Effluent Limitations Guidelines and Standards for the Steam Electric Power Generating Point Source Category: EPA's Response to Public Comments

Part 5 of 10

7. Industry Operations

Figure 7. Allen ABMet Plant Daily Influent and Effluent Total Mercury Concentrations for Paired Data Above the DL

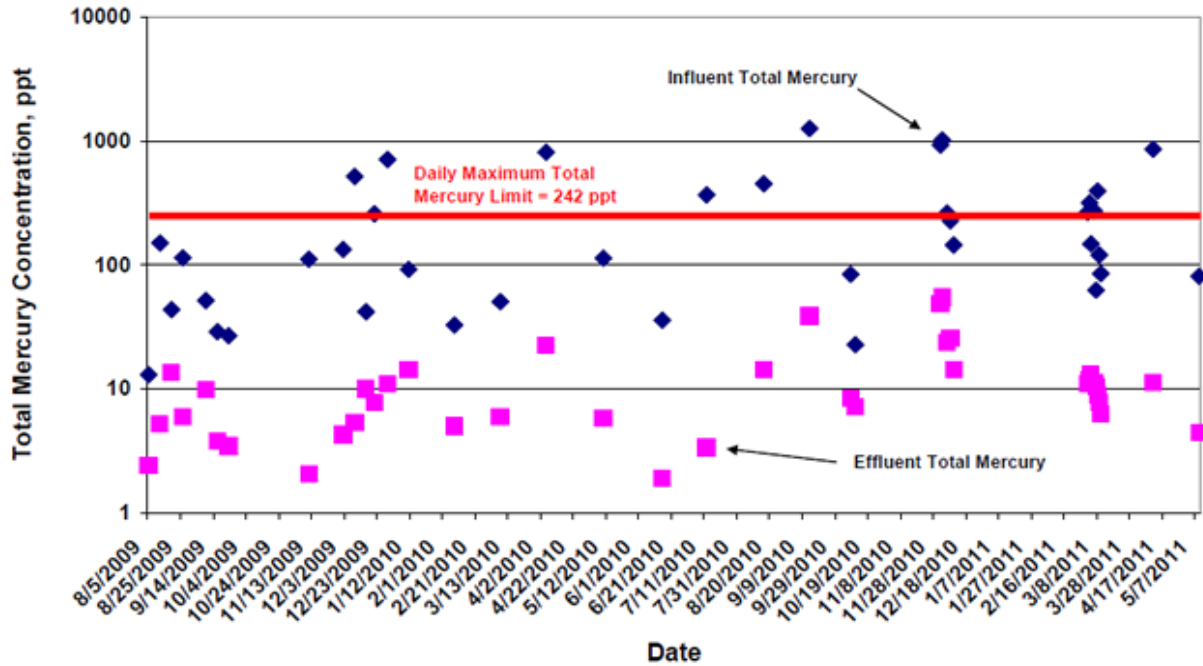
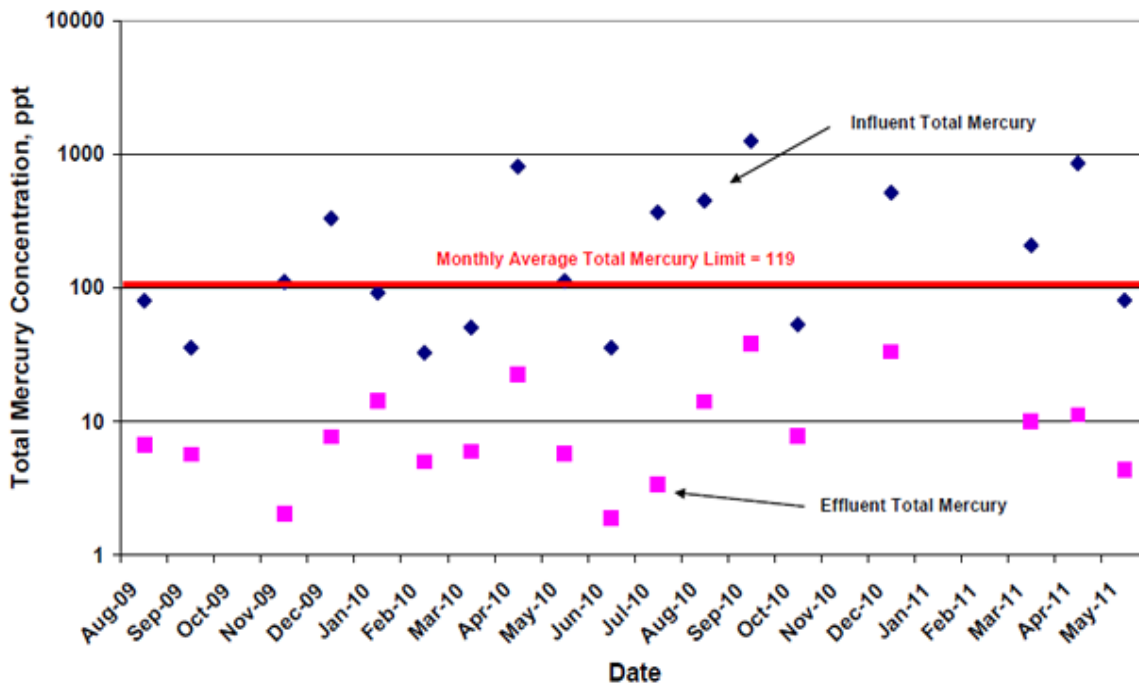
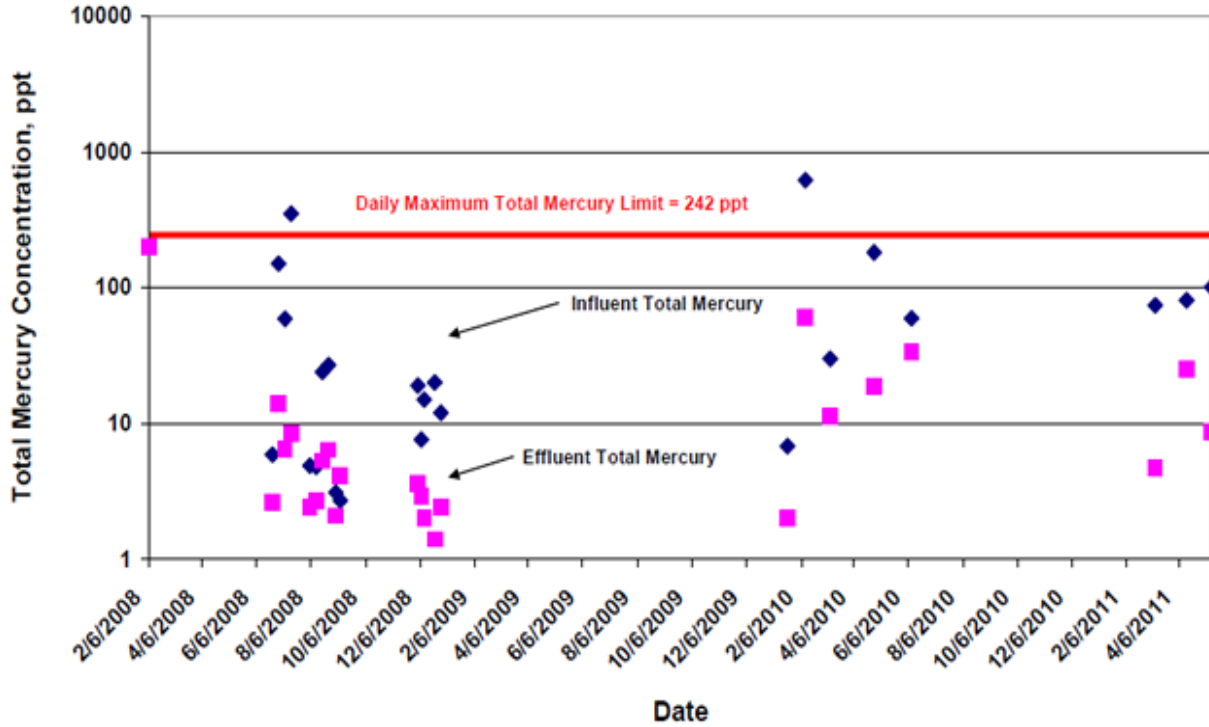
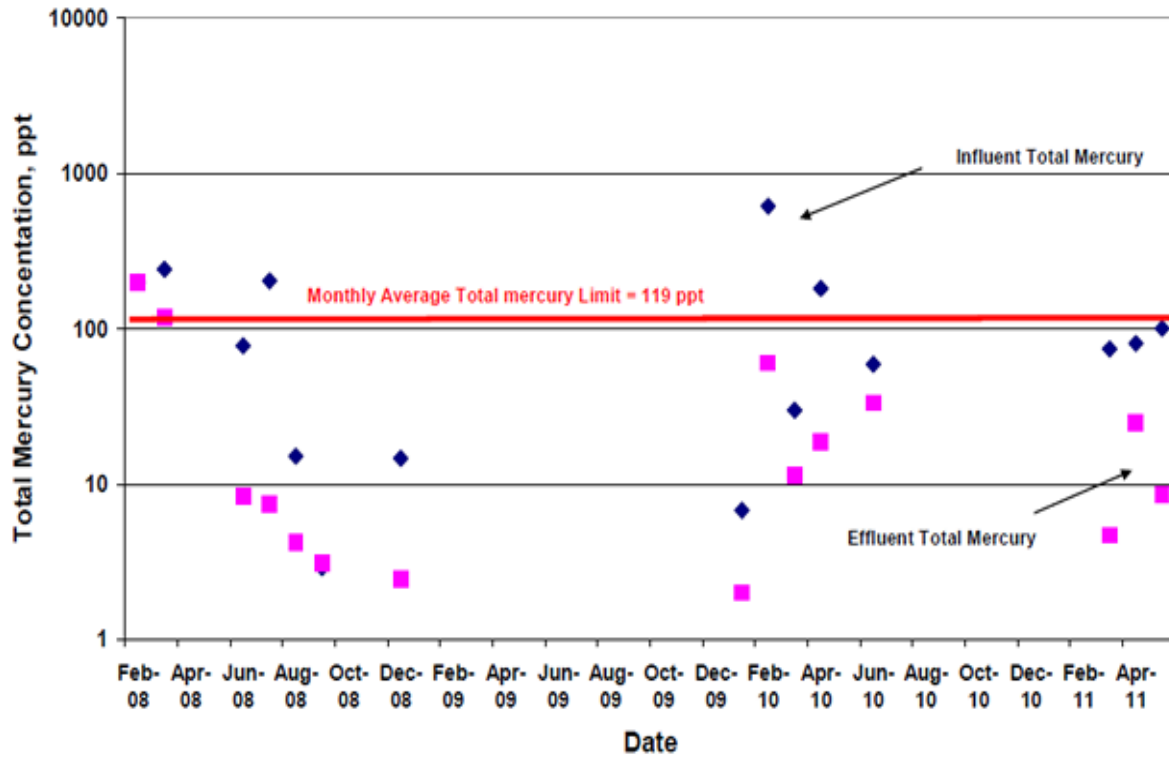
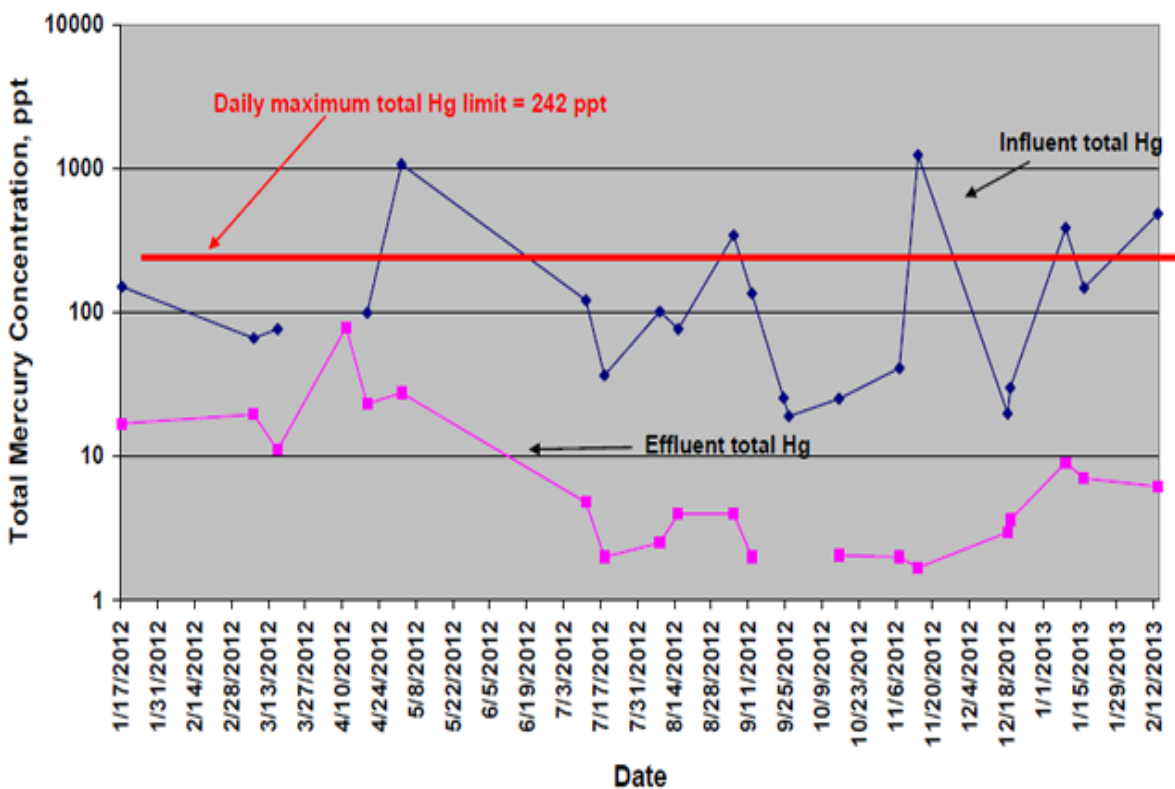
Figures 7-11 show the Hg removal performances of the Allen, Belews Creek and NE USA full-scale ABMet® biological treatment systems. The combined “Chemical Precipitation and Biological Treatment” processes at all three units were able to comply readily with the proposed EPA daily maximum and monthly average total Hg limitations.

Figure 12. Allen ABMet Plant: Relationship Between Influent and Effluent Total Mercury Concentrations for Paired Data

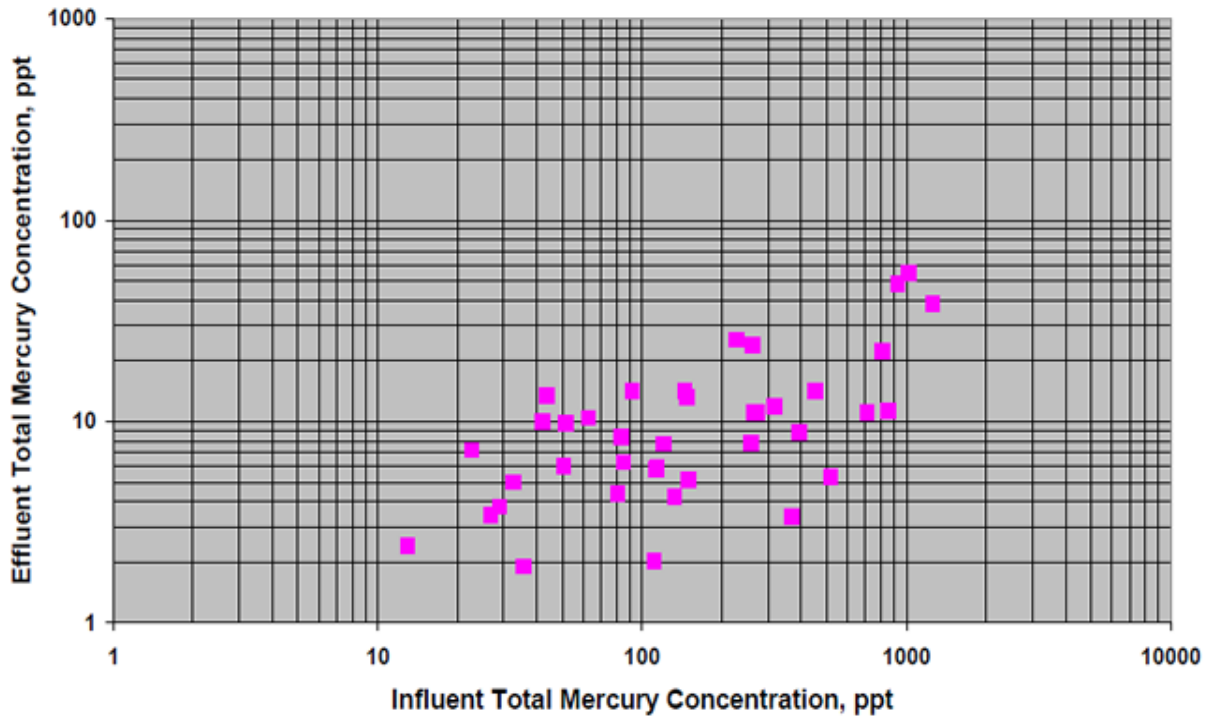
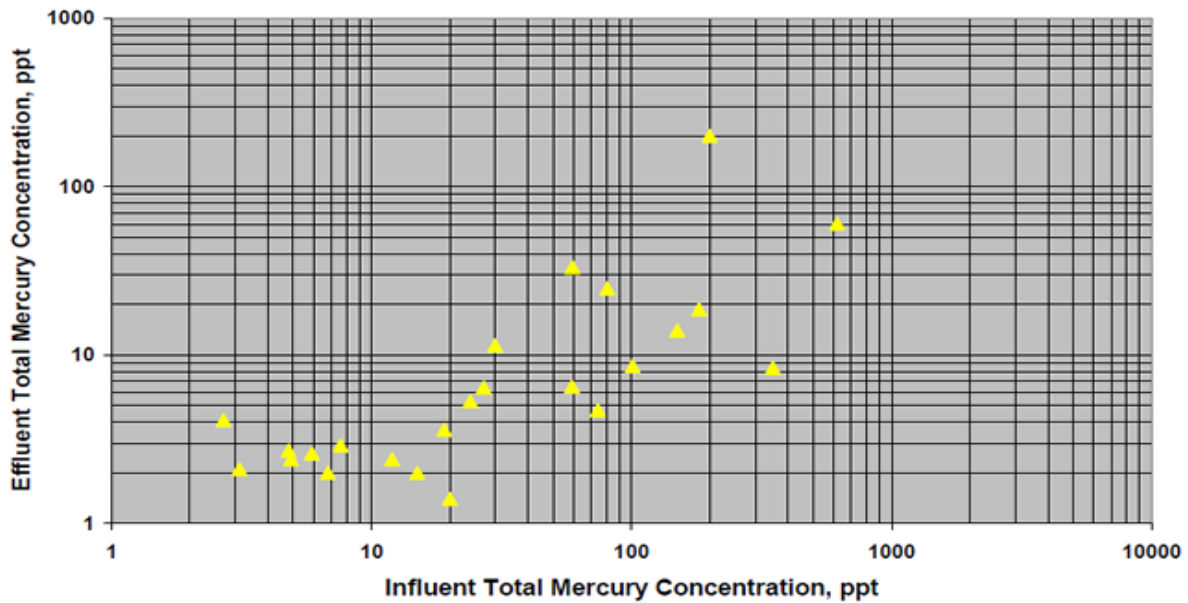
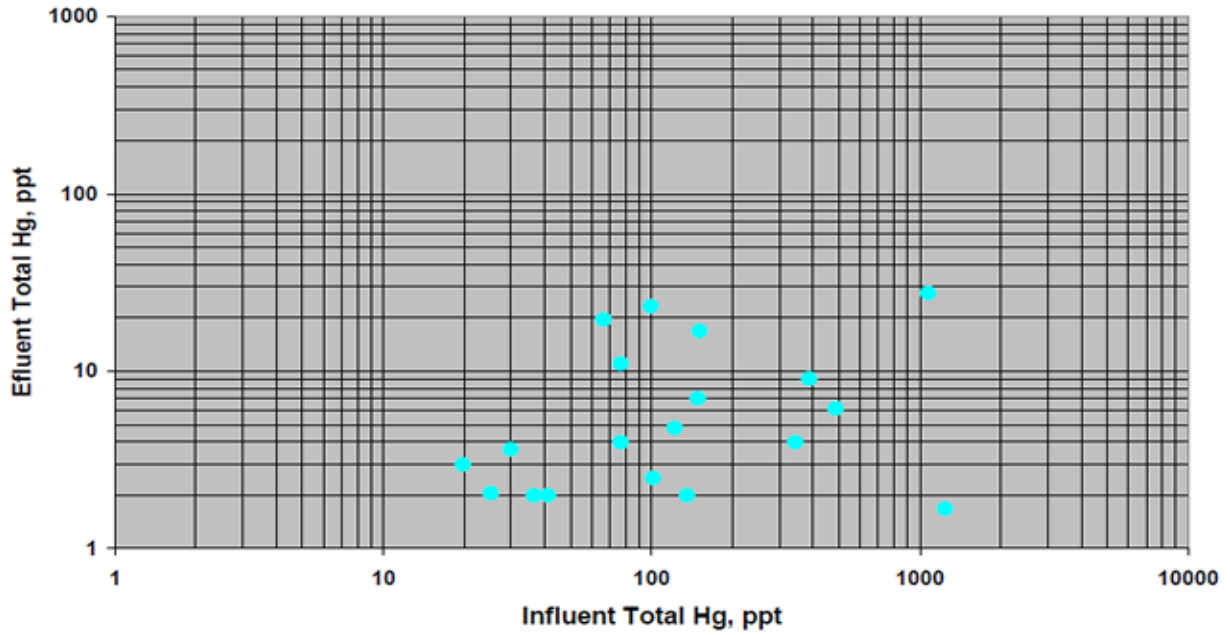
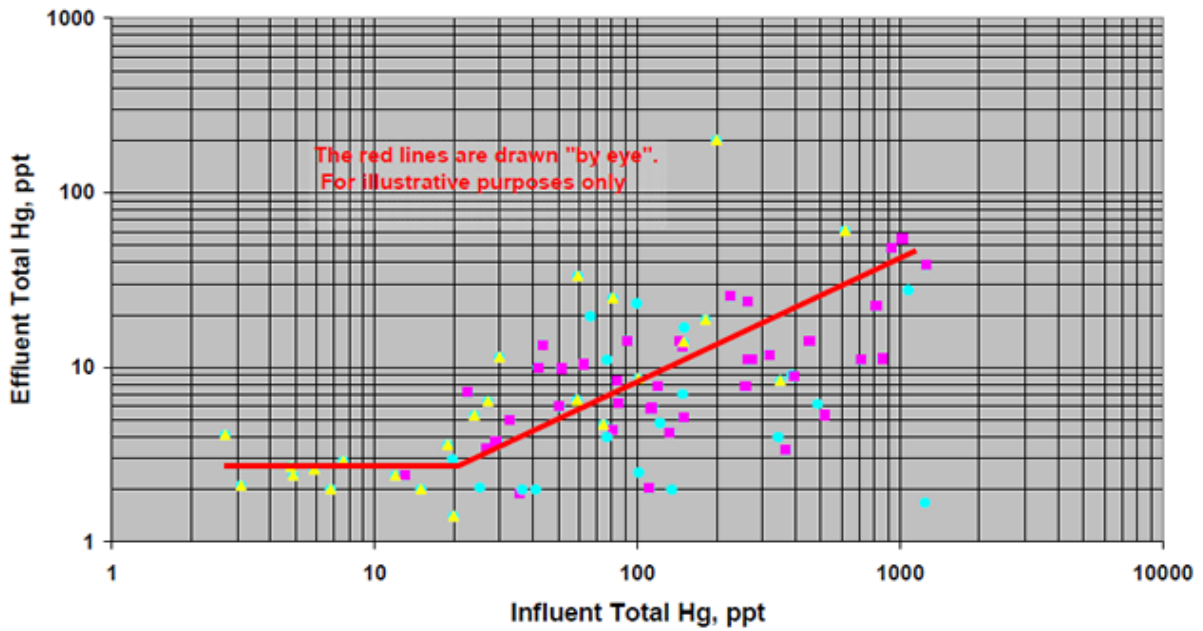
Furthermore, in all of the ABMet® plants evaluated the biological stage of the “Chemical Precipitation and Biological Treatment” provided additional Hg removal over that obtained by the chemical precipitation step (Figures 12-14) both when the precipitation step employed hydroxide only and when it employed hydroxide plus polysulfide. The magnitude of this additional Hg removal was investigated further by examining paired daily influent and effluent total Hg values that were above the detection limit. The additional Hg removal appeared to be a function of the biological system influent total Hg concentration (Figure 15). The anaerobic biological system effluent total Hg concentration seems to be proportional to the biological system influent total Hg over an influent total Hg range from approximately 1000 ppt to approximately 20 ppt. Below an influent total Hg concentration of approximately 20 ppt the effluent total Hg concentration does not decrease below the approximate range of 1-4 ppt.

These results demonstrate the advantage of producing as low as possible effluent total Hg levels from the chemical precipitation step (and therefore in the biological system influent). This effect is most clearly seen when the total Hg removal performances of the Belews Creek/Allen systems (with only hydroxide precipitation) and the NE USA system (with hydroxide and polysulfide precipitation) are compared. By attaining much lower biological system influent total Hg concentrations through hydroxide plus polysulfide precipitation the NE USA biological unit was able to produce much lower effluent total Hg levels than the Allen and Belews Creek systems with just hydroxide precipitation.

Figure 5-6
Comparison of Total Mercury Effluent to Proposed Mercury Limits for Pleasant Prairie
Source: We Energies

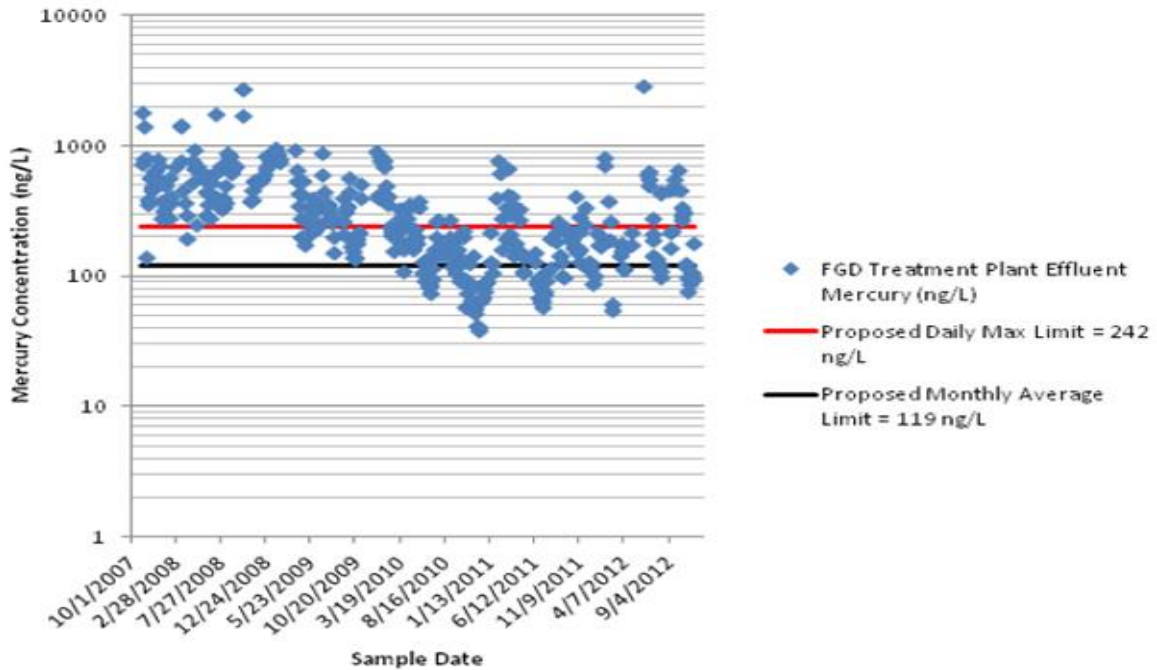
The effluent data collected at Pleasant Prairie by EPA during EPA and Clean Water Act (CWA) sampling shows that concentrations of mercury were below the proposed daily limit for all samples, but exceeded the proposed monthly limit twice during the CWA sampling. However, a review of long-term monitoring data for effluent mercury (Figure 5-6) shows that Pleasant Prairie would not be able to consistently meet the proposed daily maximum limitation of 242 ng/L or the proposed monthly average limitation of 119 ng/L for mercury.

Figure 5-7
Comparison of Total Arsenic Effluent Long-Term Data to Proposed Arsenic Limits for Pleasant Prairie
Source: We Energies

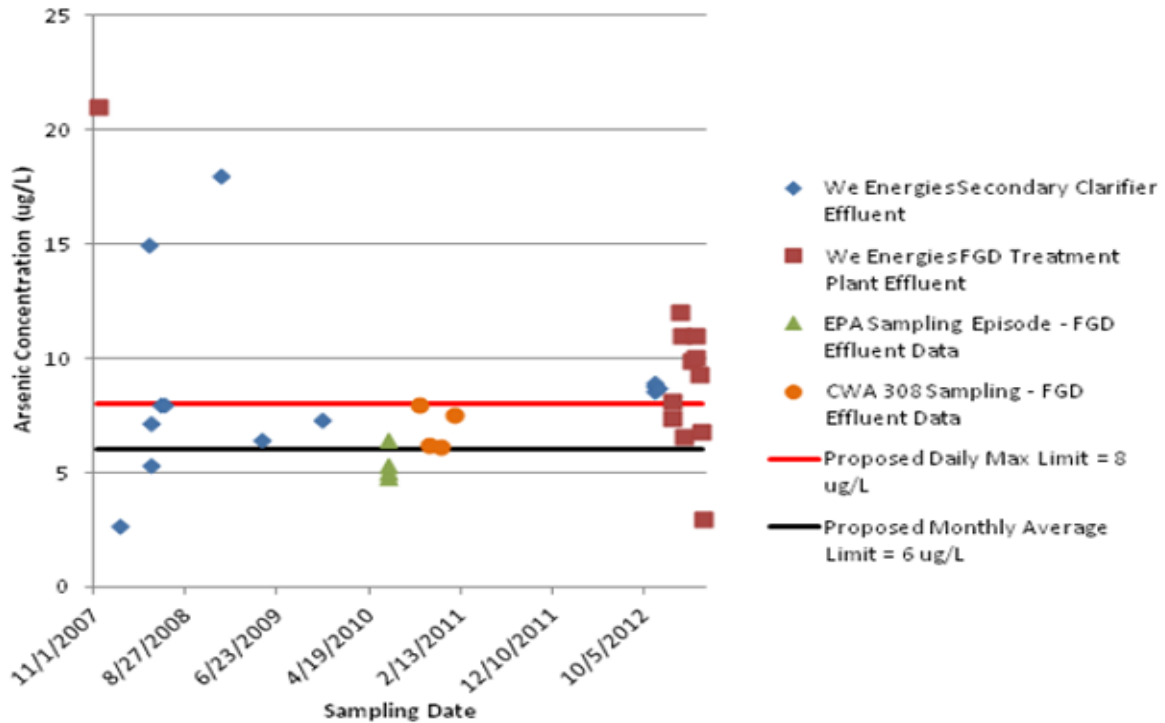
The effluent data collected at Pleasant Prairie by EPA during EPA and CWA sampling shows that concentrations of arsenic exceeded the monthly limitation of 6 µg/L for 5 of 8 samples. Additionally, review of long-term data on effluent arsenic from Pleasant Prairie (Figure 5-7) shows effluent arsenic as high as 21 µg/L. Thus, the site cannot consistently meet the proposed monthly average limitation of 6 µg/L and the proposed daily maximum limitation of 8 µg/L.

Figure 5-10
Range of FGD Wastewater Influent Dissolved Arsenic Levels

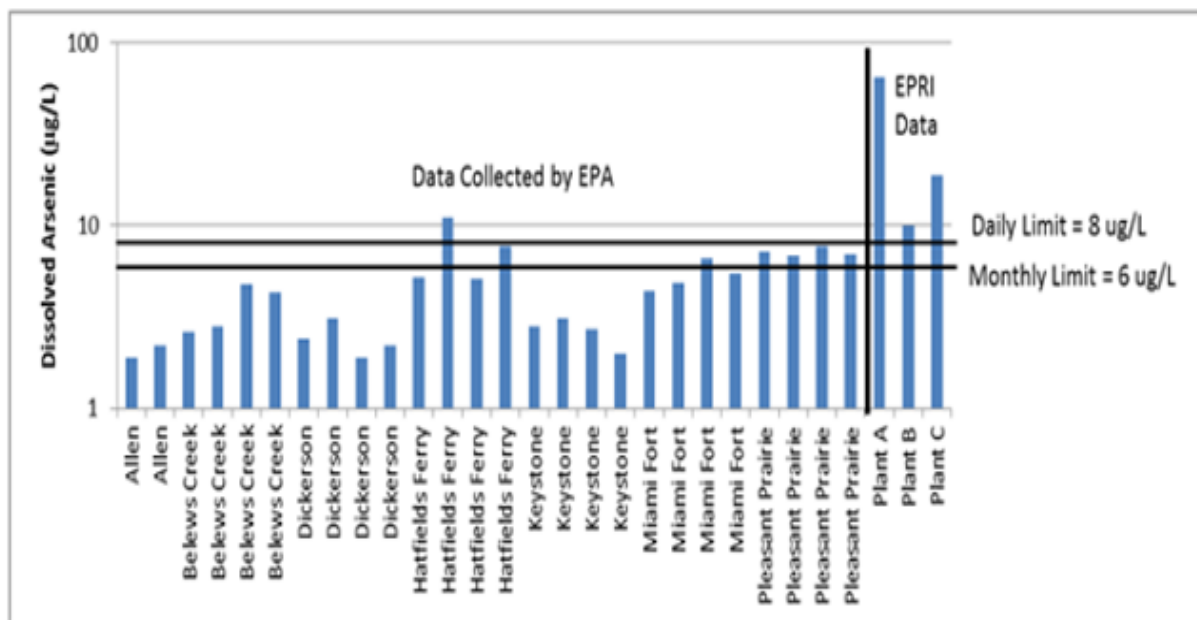
The influent dissolved arsenic levels present at BAT sites are low compared to those in data reported by facilities in the ICR or collected by EPRI as part of past studies. Figure 5-10 shows a range of influent dissolved arsenic levels in FGD wastewater from an EPRI characterization study [EPRI, 2008]. The sites where EPA collected samples showed low influent dissolved arsenic, often in the single-digit ppb range. Sites with high influent dissolved arsenic may have more difficulty in achieving the proposed limits set by the ELG for arsenic in FGD wastewater.
